### **III. AMENDMENTS TO THE DRAWINGS**

### V. REMARKS

Fig. 1 *PRIOR ART*

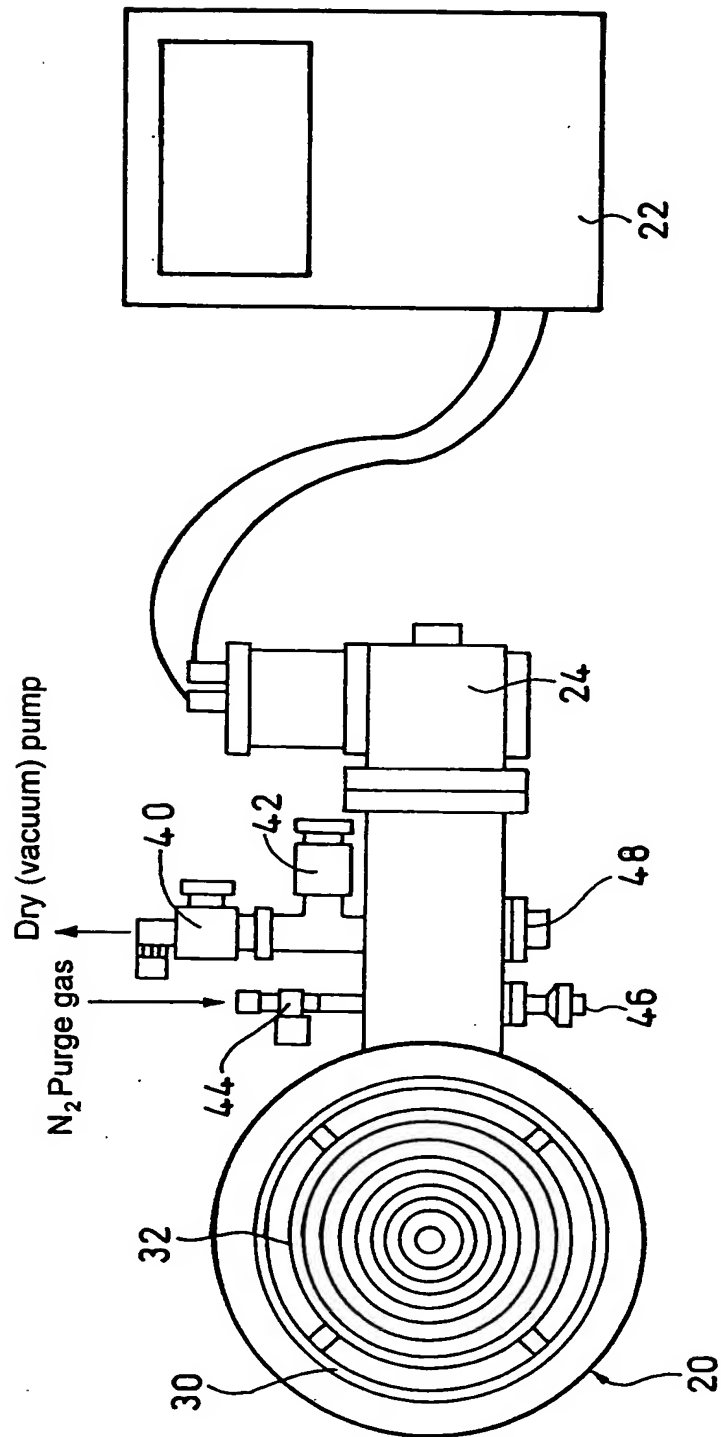
The Office Action states that Figures 1-3 should be designated by a legend such as "Prior Art". However, it appears that Figure 4 should also be designated by the legend, "Prior Art". The attached Replacement Sheets of Drawing Figures 1-4 indicate that these drawing figures are "prior art".

Formal Replacement Drawing Figures 1-4 and 7 are filed herewith. Replacement Drawing Figures 1-4 illustrate the legend "Prior Art". It is respectfully submitted that Replacement Drawing Figures 4 and 7 illustrate, by dotted lines, a time when a temperature of the portion of the case in which ice is condensed reaches the melting point of ice.

Fig. 4 *PRIOR ART*

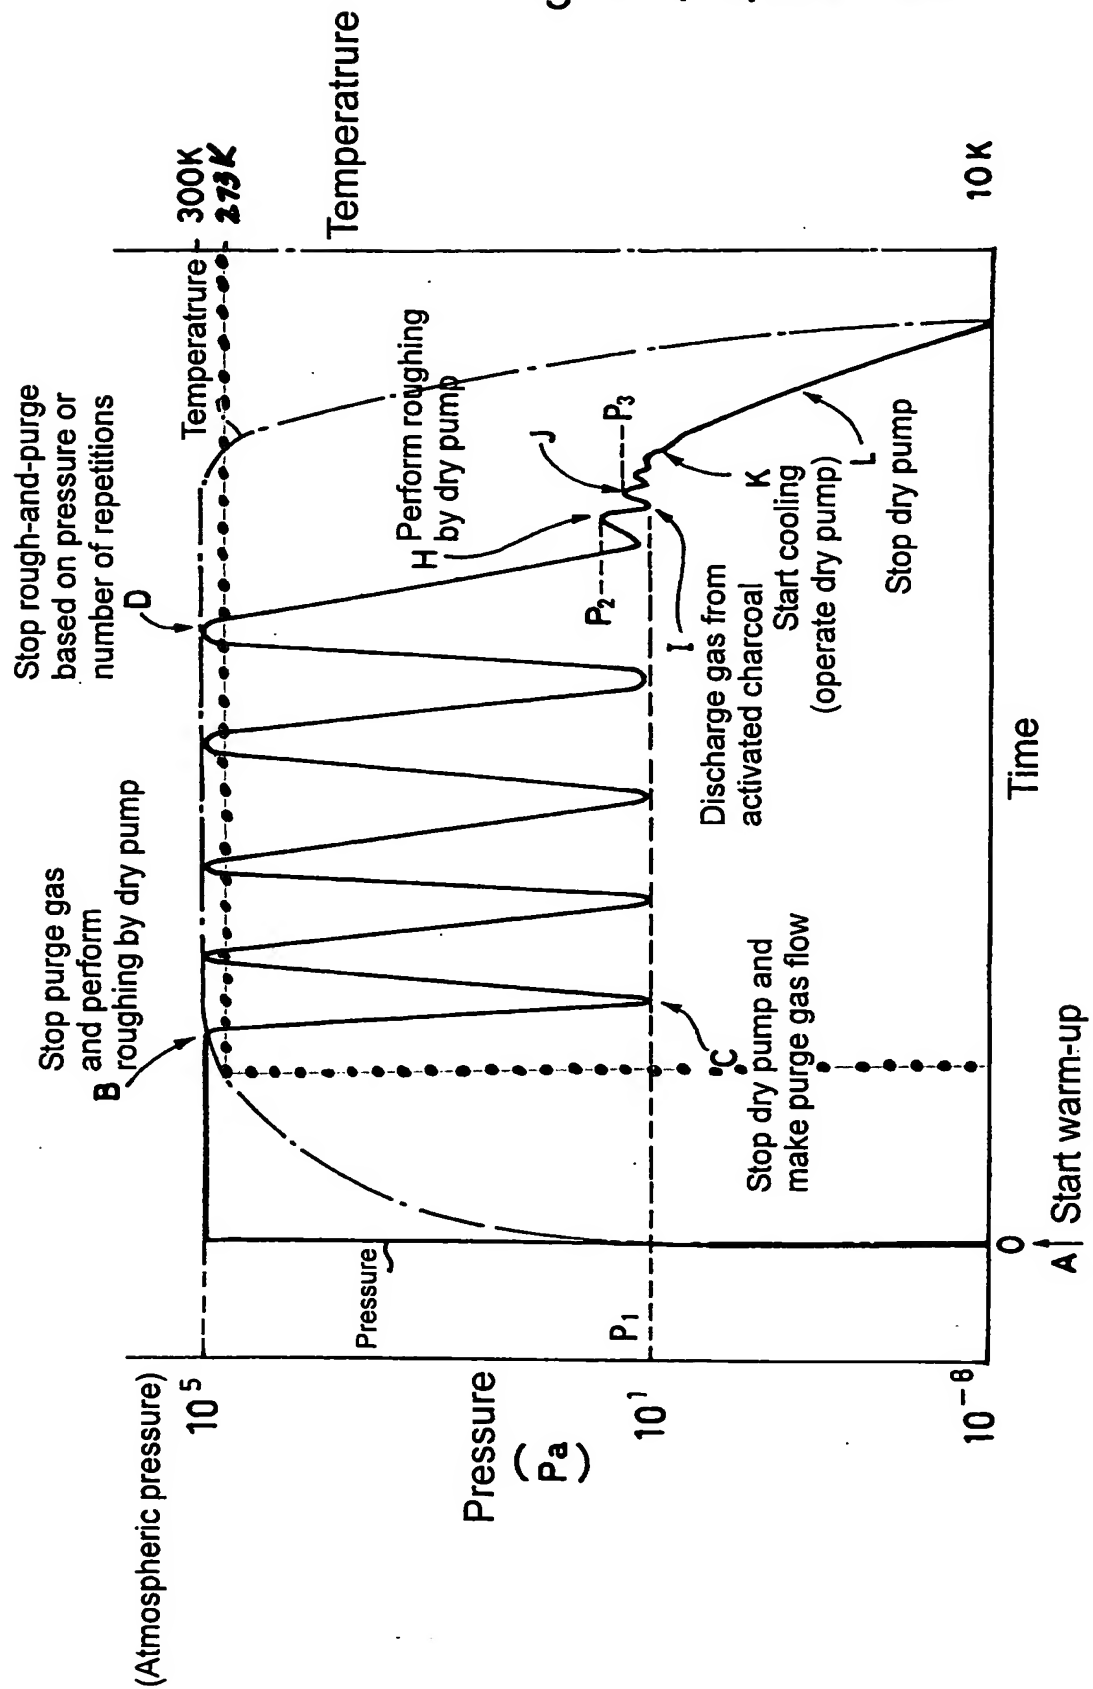
The Office Action objects to the drawing figures under 37 CFR 1.83 (a) because, allegedly, the drawing figures fail to show every features specified in the claims. The Examiner particularly points out the phrase, "time when a temperature of the portion of the case in which the ice is condensed reaches the melting point of the ice". The Replacement Sheets of Drawing Figures 4 and 7 obviate the objection by incorporating dotted lines in these charts. Withdrawal of the objection is respectfully requested.
